Docket Item # 13
BAR CASE # 2009-0153

BAR Meeting
July 29, 2009

ISSUE: Alterations
APPLICANT: Barbara J. Waite
LOCATION: 219 North Columbus Street
ZONE: RM/Residential

Figure 3. Photo of existing door.

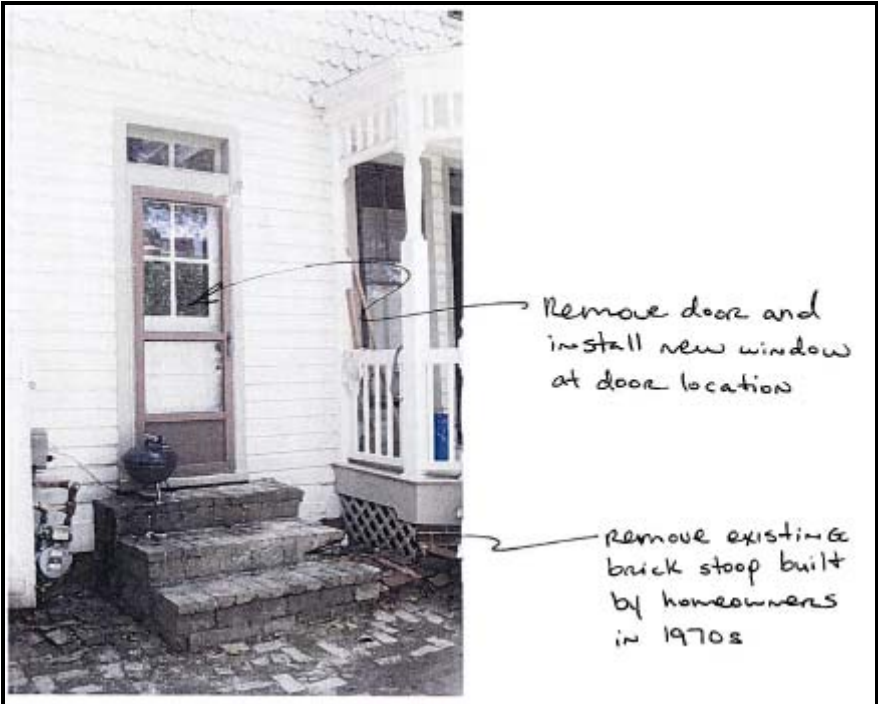
Staff has no objection to the removal of the door and the installation of a new window in the opening. The existing house has four separate entrances; in part because the house contained two units up until 1997, when the current owners converted the house into a single residence. The applicant has indicated that the Board discussed the excessive

number of entrances during one of the previous BAR hearings on the subject property. It is unclear if this door and transom are original, or later alterations made when the house was divided into two units. Staff does not support the applicant's request for a double glazed window with an interior spacer bar on this late 19th century house. The existing windows on the house are single-glazed, two-over-two wood windows with exterior storms, many of which appear to be original.

IV. STAFF RECOMMENDATION: Staff recommends approval of the application with the condition that the new two-over-two wood window be either:

1. single-glazed, true divided light; or,
2. double-glazed, true divided light, and not simulated divided light as requested by the applicant.

Figure 6: Window specification.

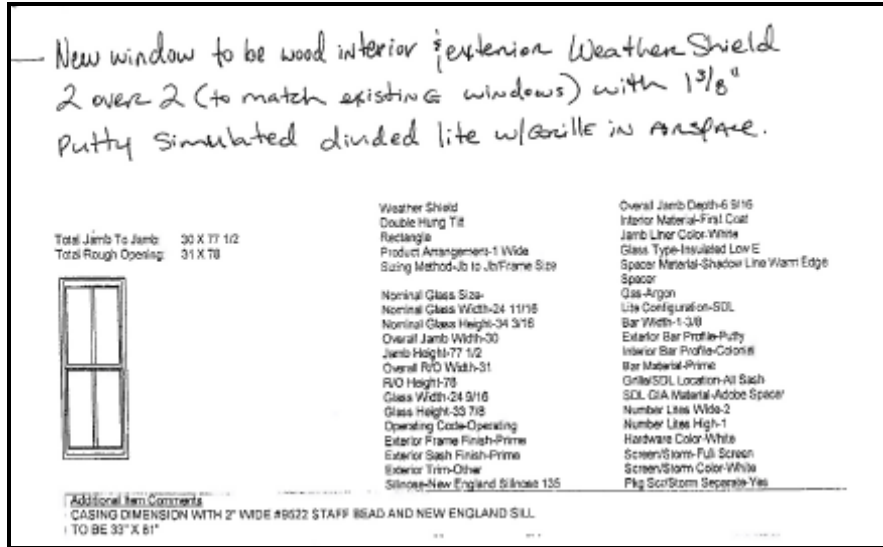
The *Design Guidelines* recommend that: "...replacement windows should be appropriate to the historic period of the architectural style of the building." The *Guidelines* also state that single-glazed, true divided light windows with interior storm sash are the preferred replacement window type. The *Guidelines* continue by saying other acceptable window types are "double-glazed *true* divided light wood windows." This is usually only feasible for two-over-two windows because the muntin width is typically quite wide (over 1 inch), and thus historically appropriate. Although a new single-glazed true divided light window is preferred, Staff could support the use of a two-over-two double-glazed window, provided that it has true divided lights and not simulated divided lights. In addition, the window will be set back approximately 45 feet from the front property line and is a new feature, rather than a direct replacement window.

Figure 7: Door specification.

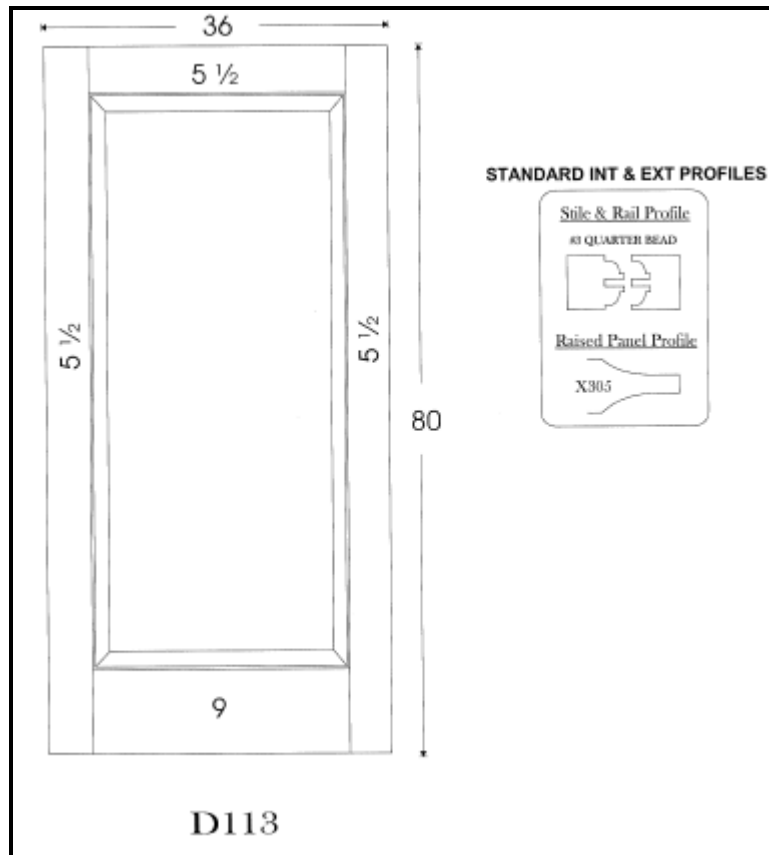
Staff does not object to the installation of the full light wood storm doors. The doors are consistent with the *Design Guidelines*, which recommend that storm doors be very simple and open, and that wood doors are strongly preferred to metal storm doors.
